Background Materials – November 24, 2025 – Planning Board Meeting

Prepared by Anne Capra, Director of Planning and Conservation, 11/21/25

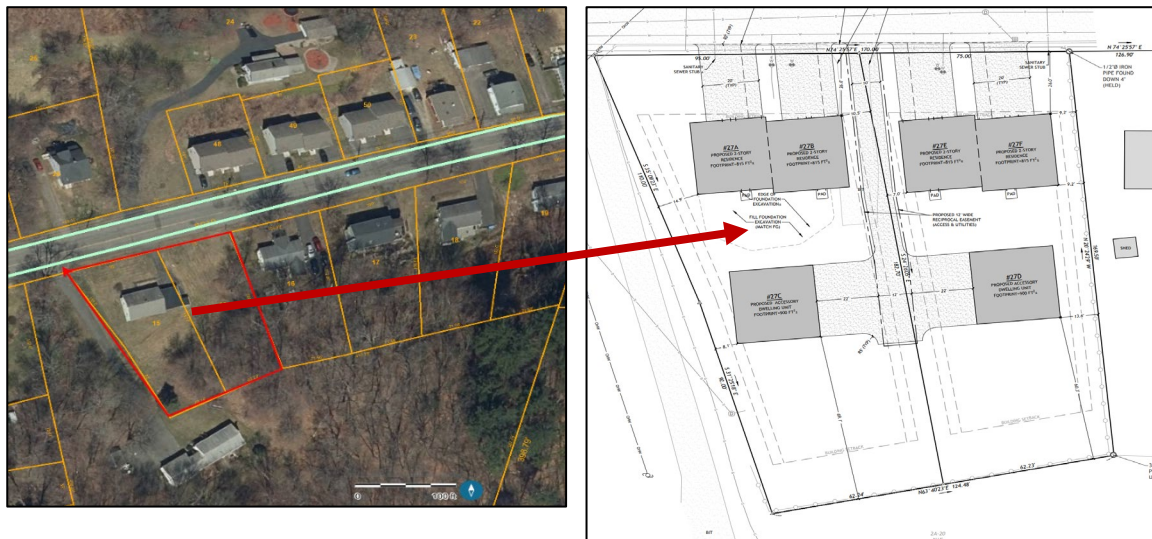
1. Further review by FD2 – *See FD2 response below.*
2. Board requested applicant provide more information regarding his assertions that there are no other feasible site layouts for location and orientation of the duplex units. *No new information has been submitted by the applicant.*

The submitted site plan shows four (4) 20’ wide paved driveways attached to the duplexes, plus an additional 10’ wide shared driveway for the two detached ADUs. The Board needs to consider whether or not an additional curb cut for the ADUs is allowable or would violate the SPR criteria.

- The detached ADUs are approx. 85' from Ludlow Road.
- Each detached ADU is located behind a duplex building.
- There appears to be 20' between the two duplexes. The applicant has proposed a 10' wide shared driveway for the two ADUs.

- If no sprinkler, the applicant must provide a 20' wide access road to the ADUs that meets the Fire Code requirements for an "access road".
- Zoning Code requirements for Site Plan Review limit the number of curb cuts to 1. The project already has 2 curb cuts for each of the duplex units, for a total of 4. Therefore, no additional curb cuts would be allowed for the new ADUs. Therefore, the applicant would need to redesign the project meet curb cut requirements under zoning, AND provide sprinklers in the ADUs.

Move to issue site plan approval upon submittal of a revised site plan eliminating additional driveway curb cut for detached accessory dwelling units on lots 1 and 2 at 27 Ludlow Road, prior to issuance of Building Permit. Building Permit is conditioned upon the Building Commissioner determination that the accessory dwelling units meet the definition of allowable gross floor area.

Existing stonewall and median display constructed by developer.

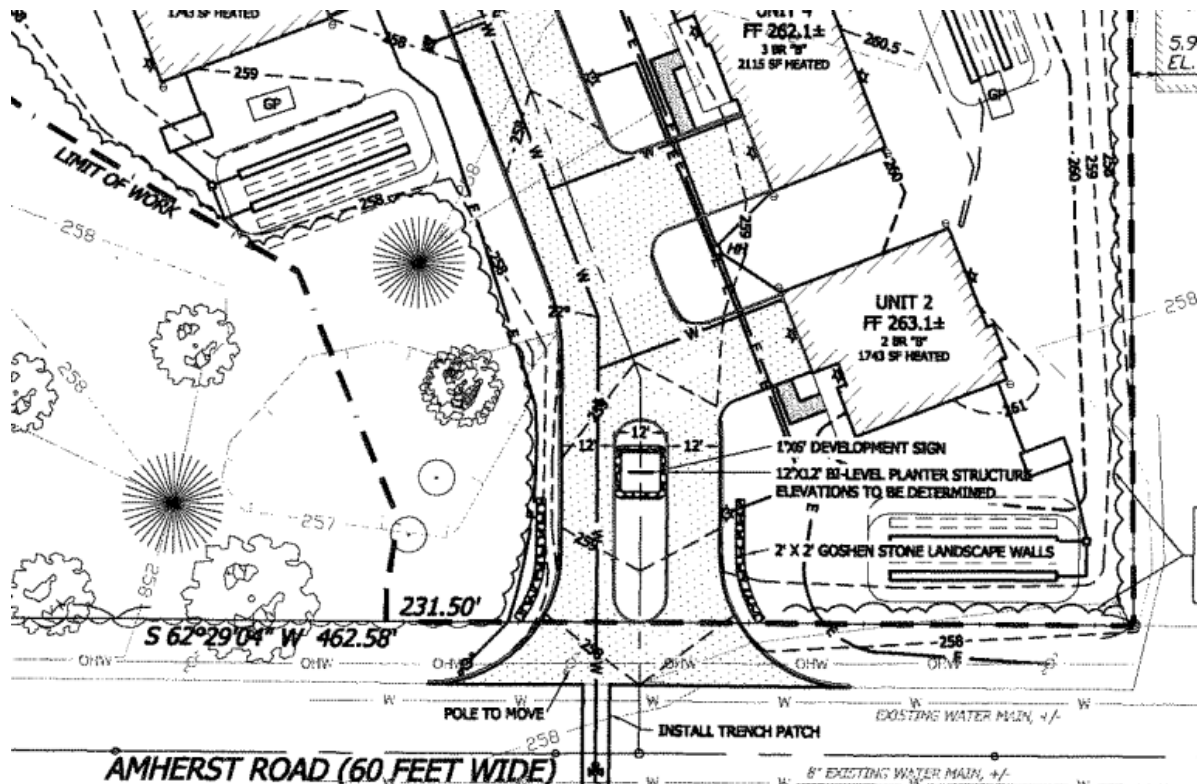
Although the existing stonewall and bilevel median display is on the approved plans, it was installed in the wrong location (too close to the road) and was paved around it thereby eliminating the intended planting area. The developer shall be required to install the plantings required for the median in another appropriate location on the site, to be approved by the Director of Planning and Conservation.

A residential development sign is permitted within this area, however, the additional "private road no outlet" is not permitted and shall be removed immediately. Other statuary including the metal birds must also be removed.
